**TOWN OF DAVIDSON
DESIGN REVIEW BOARD
7:00PM Board Room in Town Hall a 216 S Main St, Davidson, NC**

Town of Davidson, NC
Design Review Board: Staff Analysis
July 17, 2019

Project: Wells Fargo ATM (Exxon Station Site)
Location: 601 Griffith Street (Parcel ID 00321403)
Applicant: Matthew Kiger, SVW Inc.
Designer: James M. Hammill, Prizm Architects
Planning Area: Special Use

Revised Wells Fargo ATM Renderings for Design Review Board (7/17/19)

Electrical Details

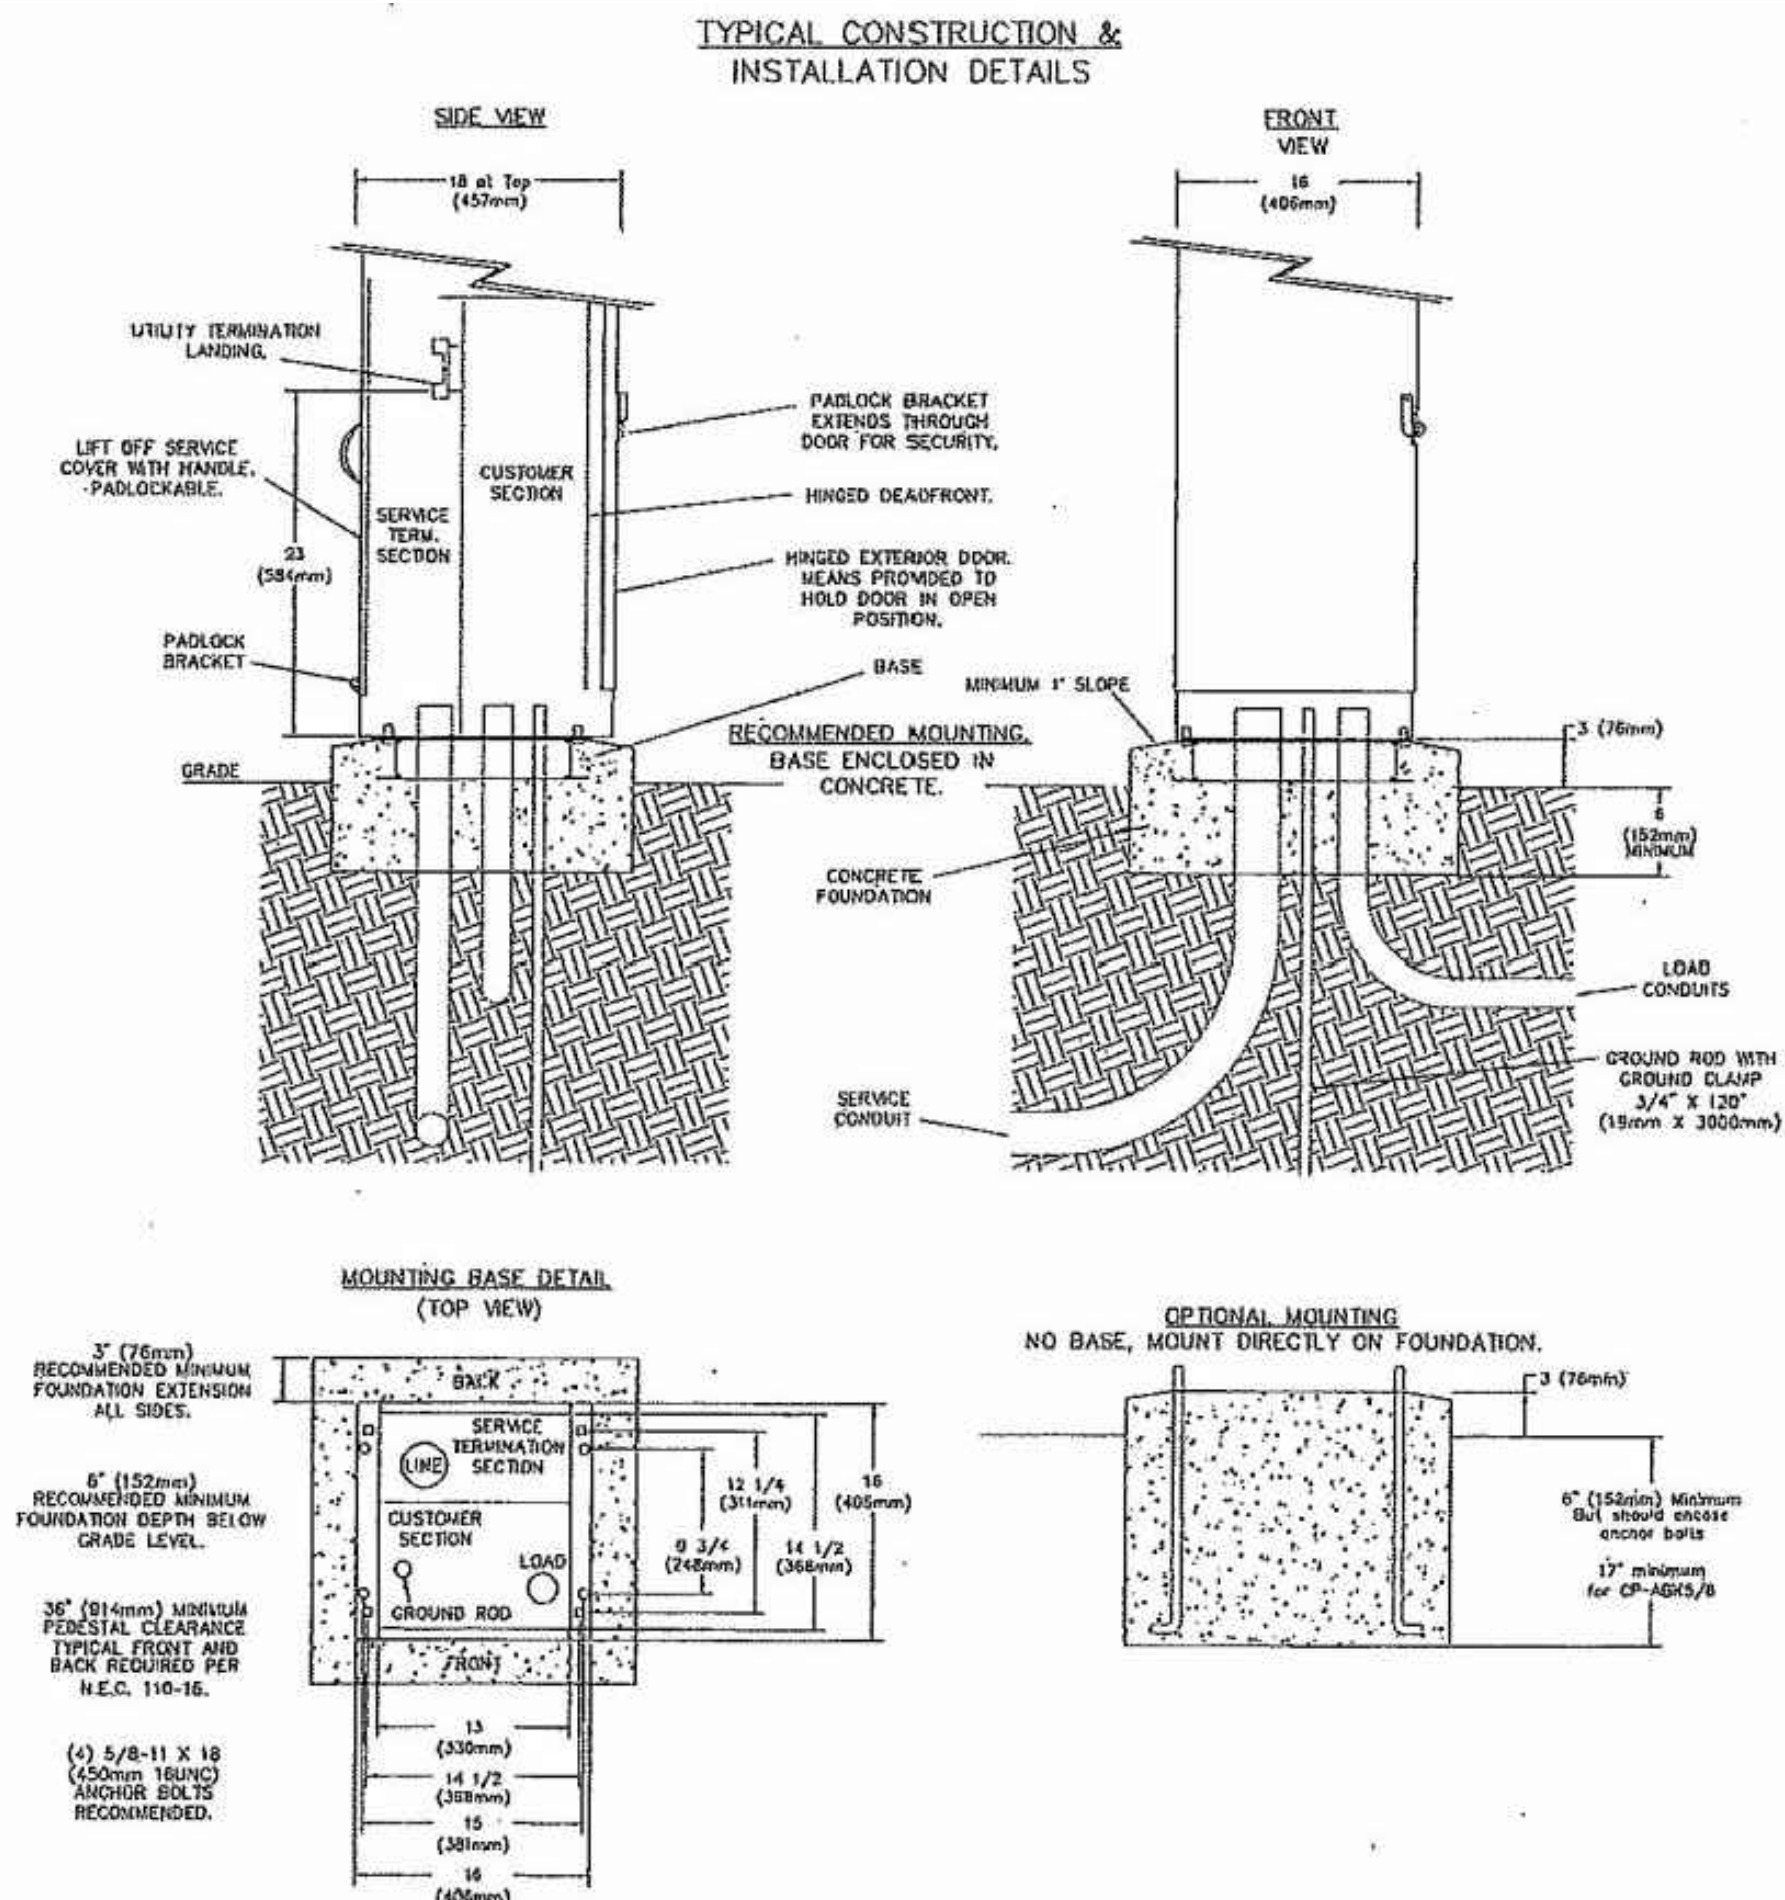
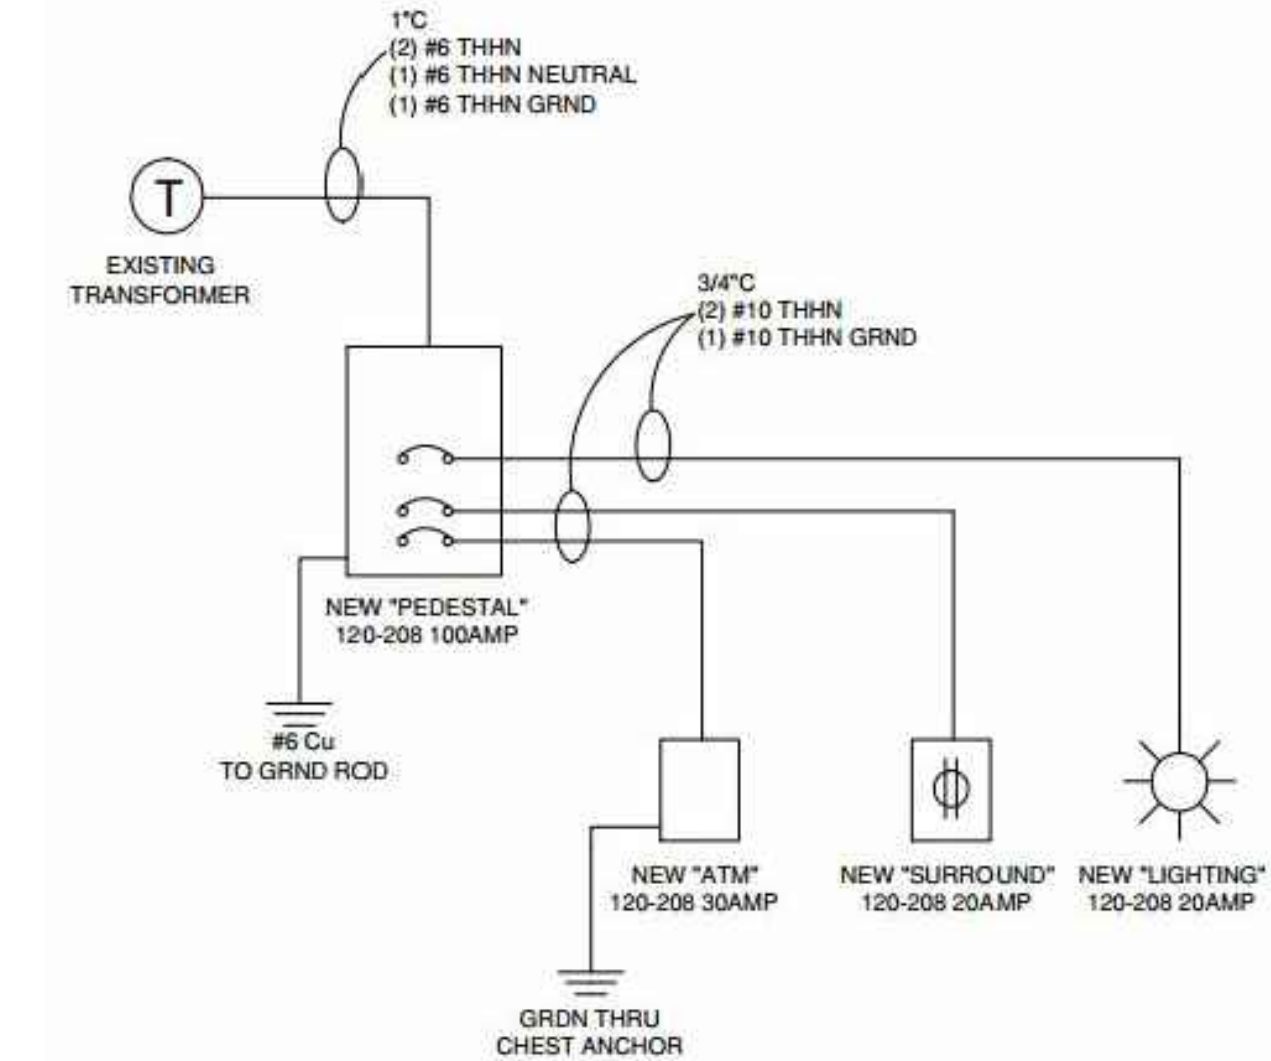
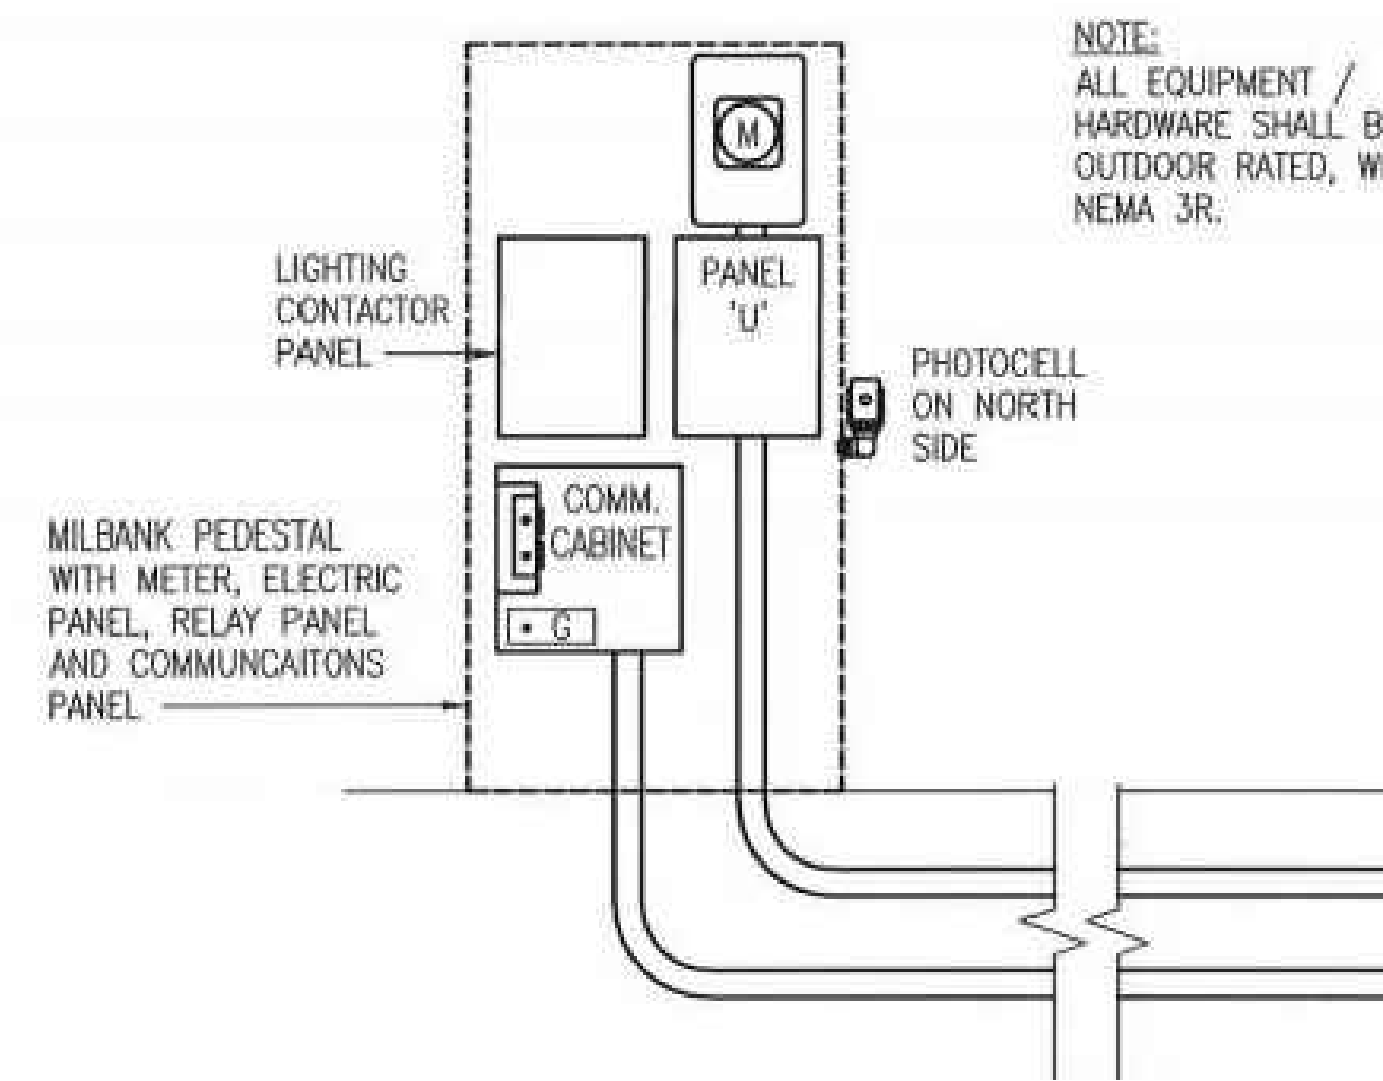
TG noted that materials must be complementary to the materials already being used in the neighborhood. The existing buildings adjacent to this site are primarily brick. Additionally, an electrical meter is shown on a pedestal facing the street in the plans submitted.

This case was continued at the June 19 DRB meeting with the following requested changes: 1) the ATM enclosure shall be clad in brick to match adjacent buildings, 2) the electrical meter shall be reoriented so that it faces away from the side of the ATM structure and does not face the parking lot or the street, 3) the color of the light pole base and clearance bar shall be painted to match the meter pedestal (bronze), and 4) the signage on top of the ATM canopy shall not be internally illuminated.
